***Ducted Systems
Technical Services
Service Tips Letter***

Letter: **ST-007-2018**

Subject: **Condensate dripping issue with Residential Early production model CM indoor coils applied in a horizontal application.**

Product: Residential CM Model cased coils: AP, AE, AVC, RFCX**22 air handling units.

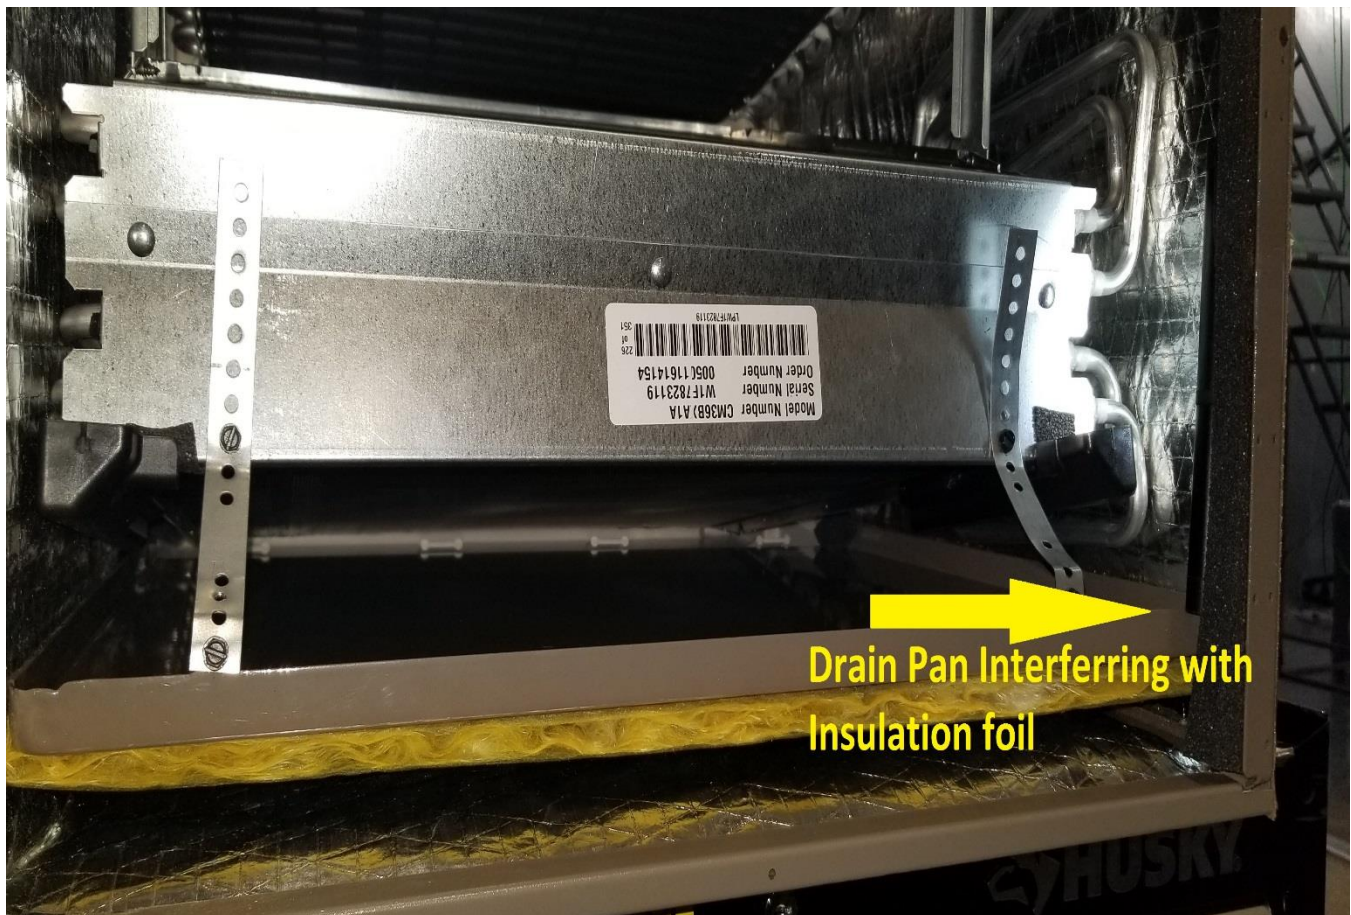
We have received some reports of condensation dripping from the distributor assembly, distributor tubes, suction header and the TXV body of the residential indoor model CM coil when applied in a horizontal application. The reports indicate small amounts of condensation not being captured by the horizontal drain pan, but falling past the pan into the coil cabinet.

Through our investigation, we discovered that the distributor assembly, tubes, suction header and TXV body of the coil may be pressing against insulation of the front panels of the coil case, which is shown below.

When condensation is formed during normal operation, the condensation has the ability to make contact with the insulation face and travel down the foil surface. Due to the design of the first generation horizontal drain pan, the drain pan may be unable to capture all of the condensation coming off the front of the coil.

Based on these findings, Design Engineering implemented a wider horizontal condensate drain pan in July of 2017. The drain pan can be identified by the edge connected to the horizontal pan straps. The first generation drain pans had a 45-degree edge. The current drain pan has a 90-degree edge. The drain pan edge was changed to improve condensate management within the pan. Shown below is a picture of the current drain pan that now has an interference fit with the insulation on the back coil cabinet and front panel. Coils produced in August 2017 (W1H7) and later contain the new wider drain pan.

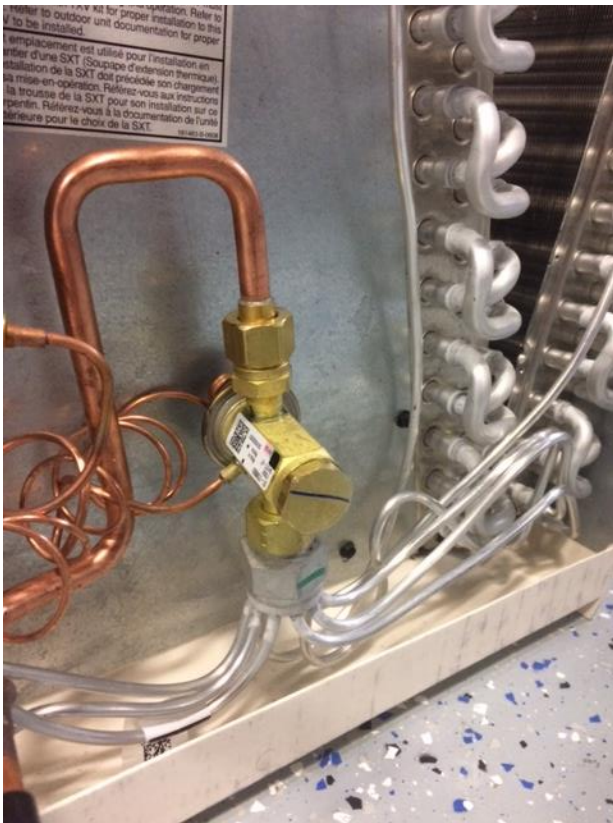
A component that can assist with managing the condensation into the horizontal drain pan when applied in horizontal applications is the “Horizontal Pan Angle Flange” and 3 “S-clips.” This item can be found in Source1 kits S1-37339479001, S1-37339472001, S1-37339473001, and S1-37339475001. Install the pan angle by following the installation instructions included with the Source 1 kit. For most applications, the pan angle must be cut to the correct length. Condensate will be more effectively captured and directed into the horizontal drain pan. See photo below of the Horizontal Pan Angle Flange after installed onto the drain pan edge.
